CONSTRUCTION SERVICES FOR ENGINE HOUSE NO. 8 RENOVATIONS AND
UPGRADES

Solicitation Number: DCAM-19-CS-IFB-0012

Addendum No. 4

Issued: June 21, 2019

**FOOD SERVICE
EQUIPMENT
PLAN &
SCHEDULE**

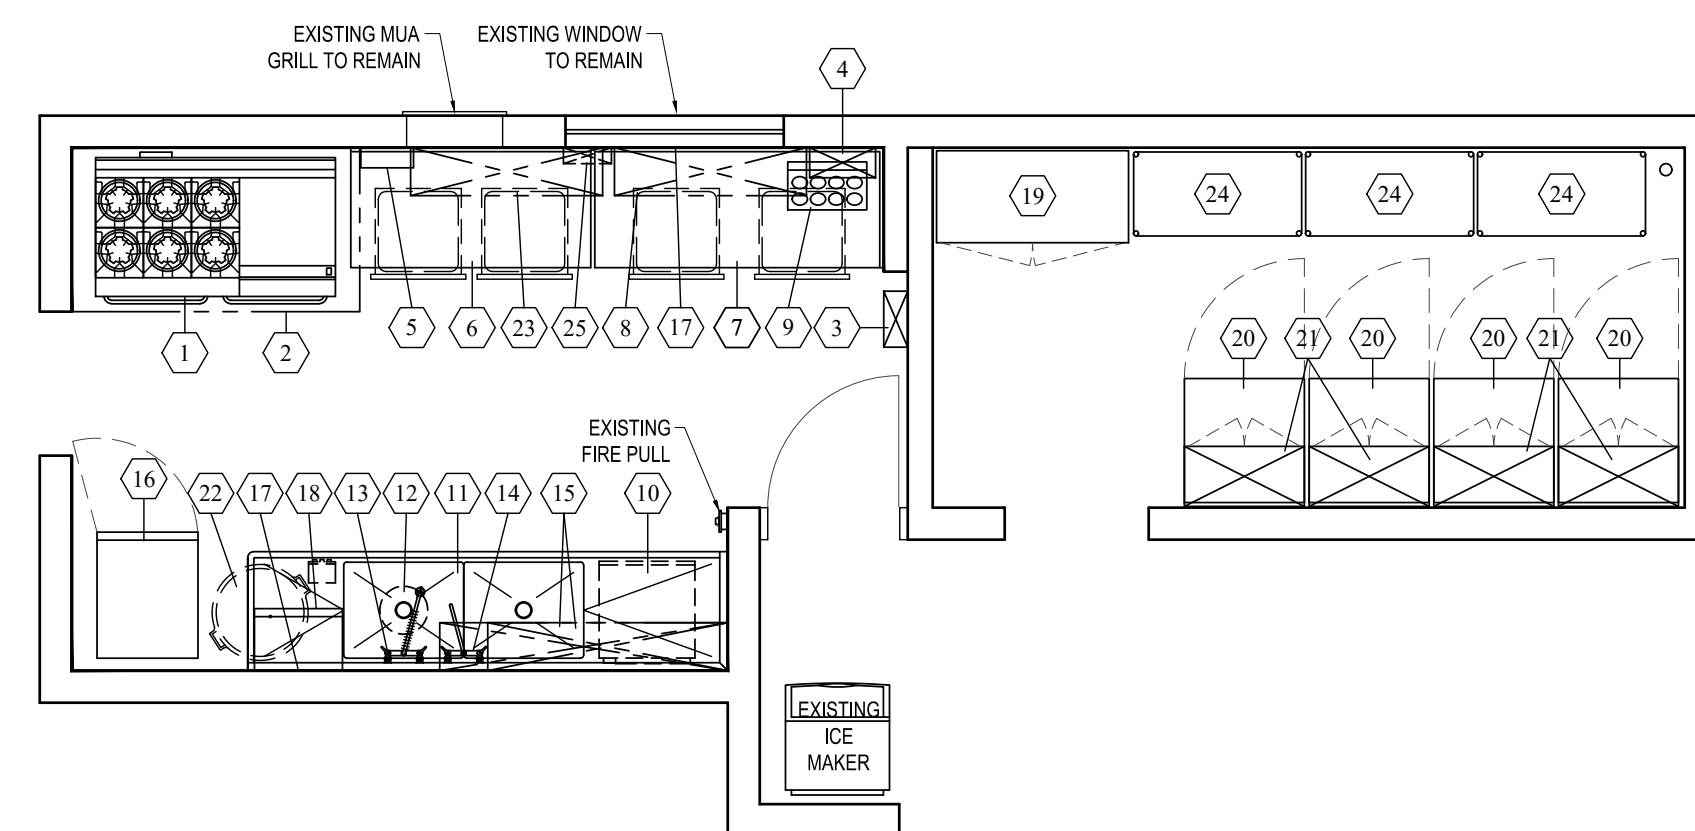
REVISIONS:	
06/13/2019	EXISTING WINDOW & MUA GRILL TO REMAIN. RELOCATE EXISTING ELECTRICAL PANEL, HOOD CONTROL PANEL & ANSUL CABINET

PLUMBING CONNECTION PLAN

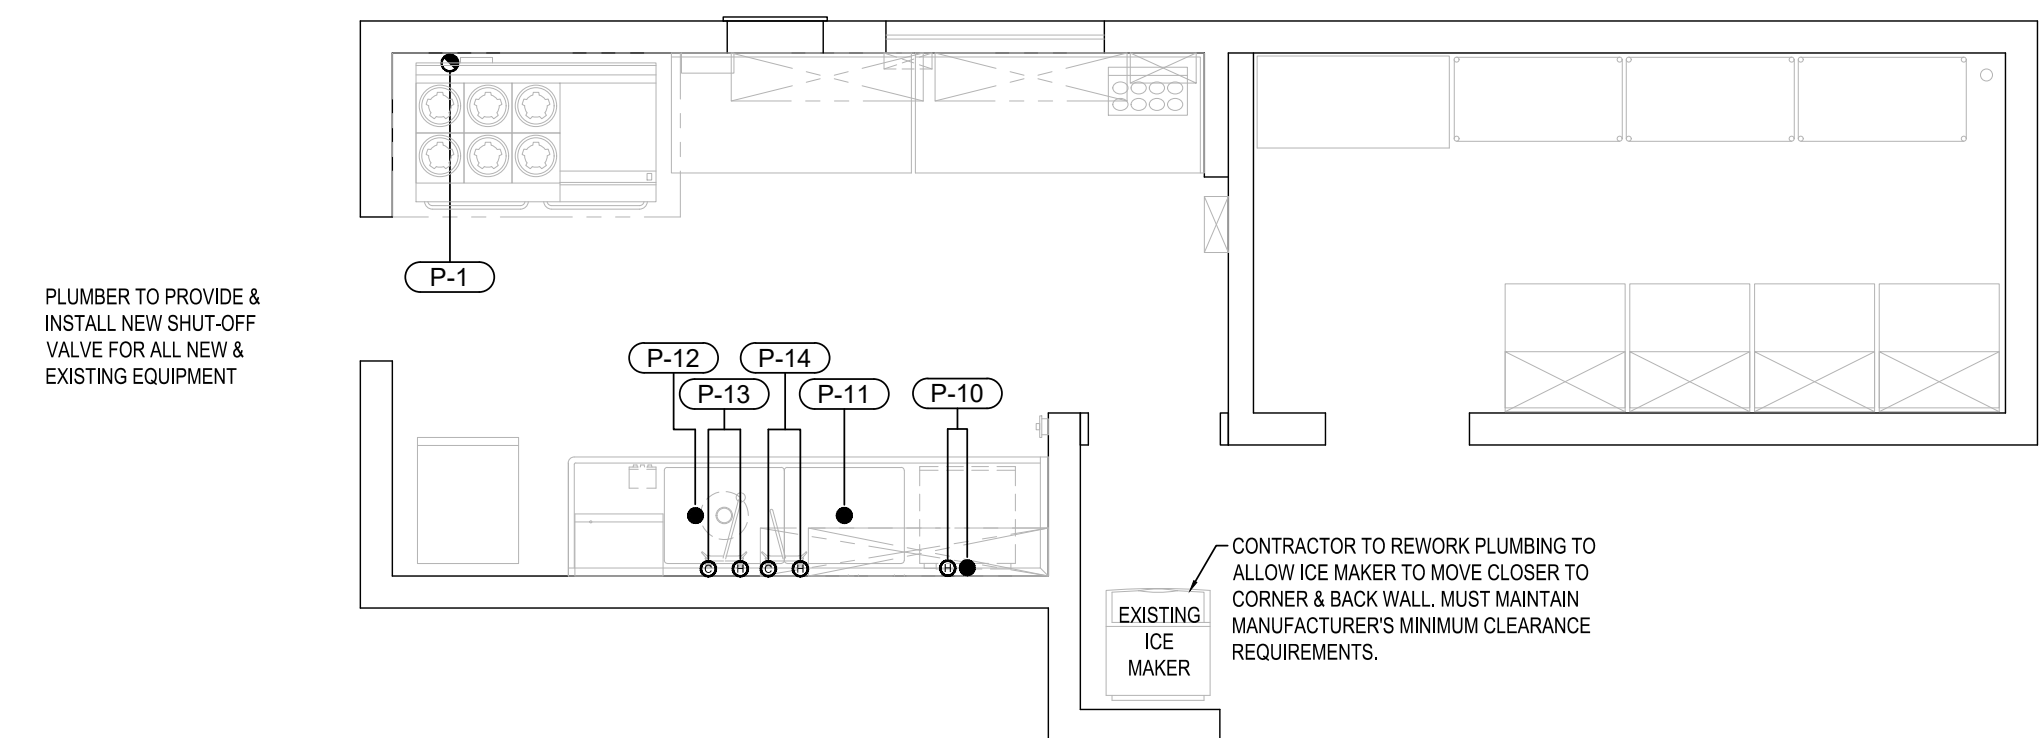
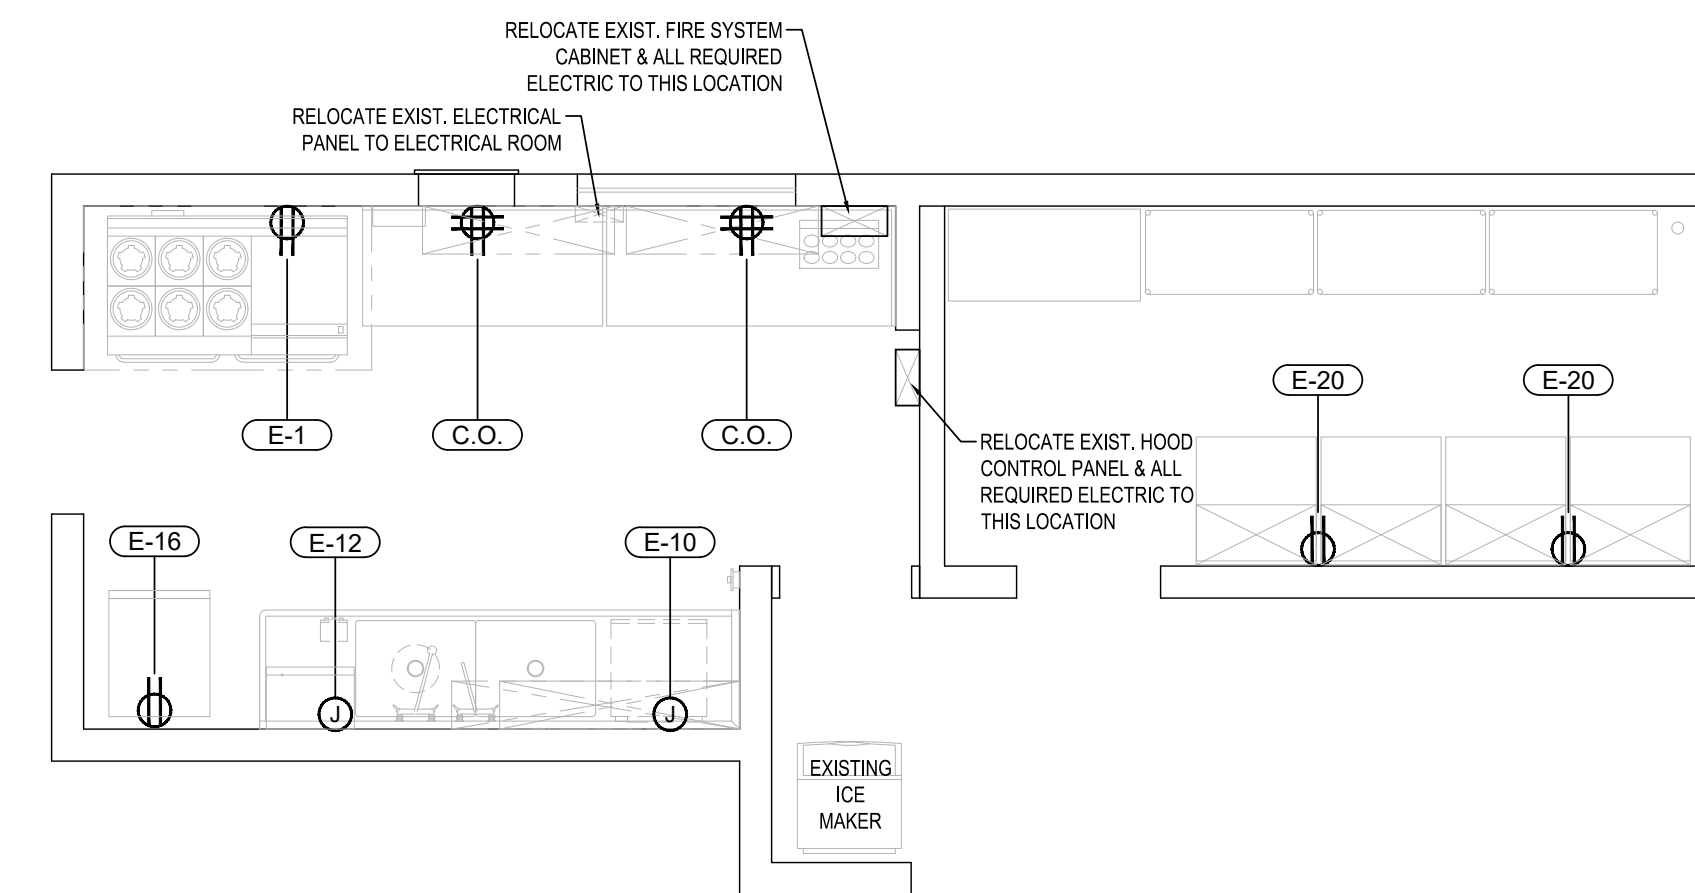
REVISIONS:	
06/13/2019	EXISTING WINDOW & MUA GRILL TO REMAIN. RELOCATE EXISTING ELECTRICAL PANEL, HOOD CONTROL PANEL & ANSUL CABINET

ELECTRICAL CONNECTION PLAN

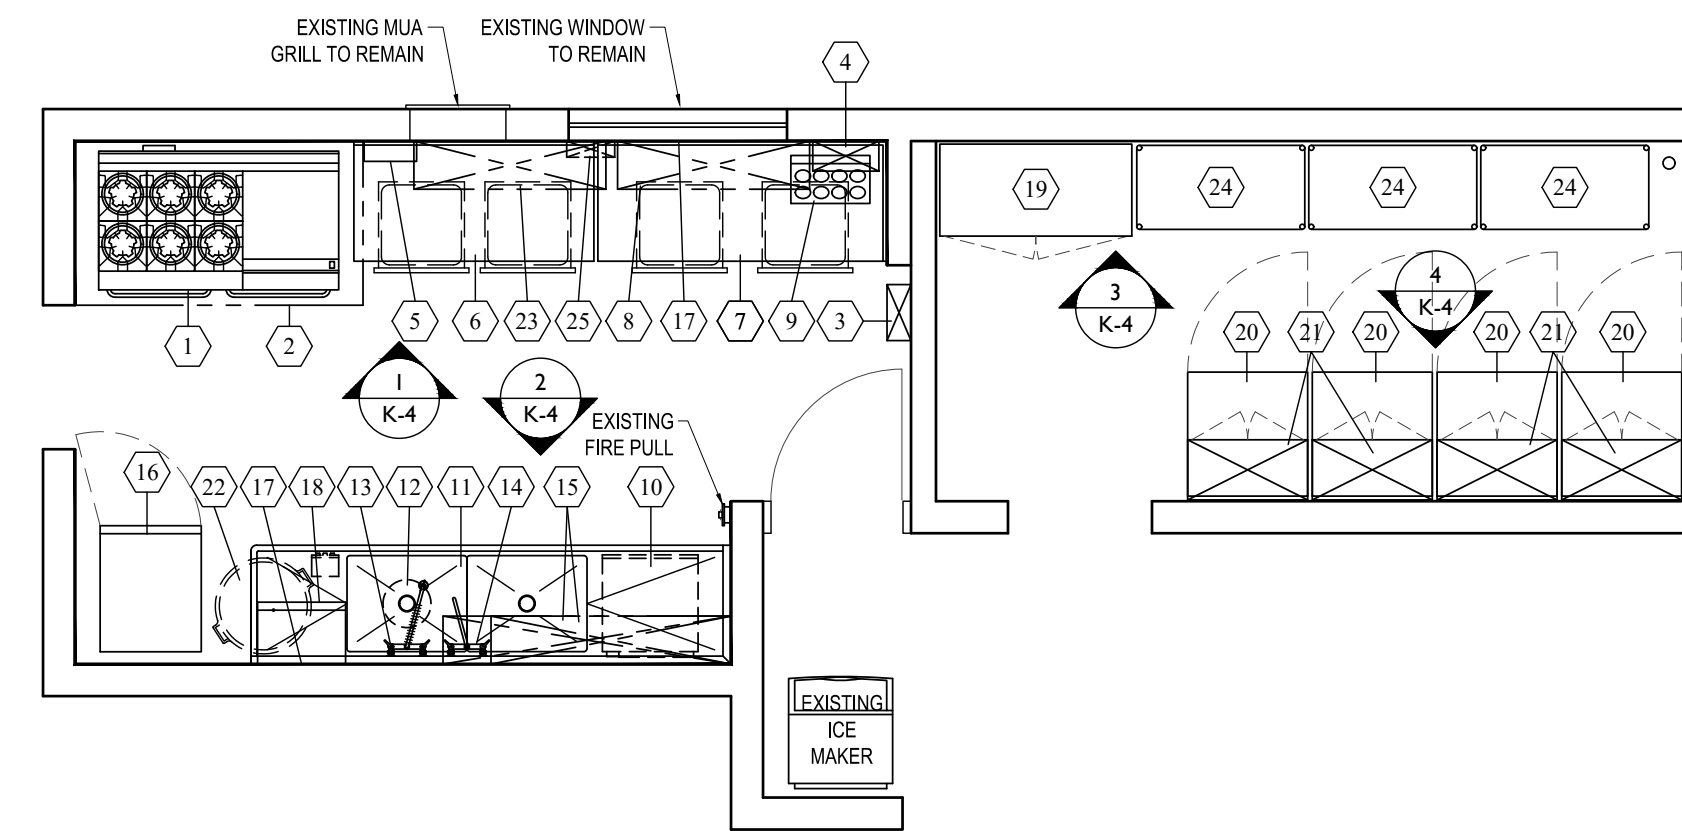
REVISIONS:	
06/13/2019	EXISTING WINDOW & MUA GRILL TO REMAIN. RELOCATE EXISTING ELECTRICAL PANEL, HOOD CONTROL PANEL & ANSUL CABINET
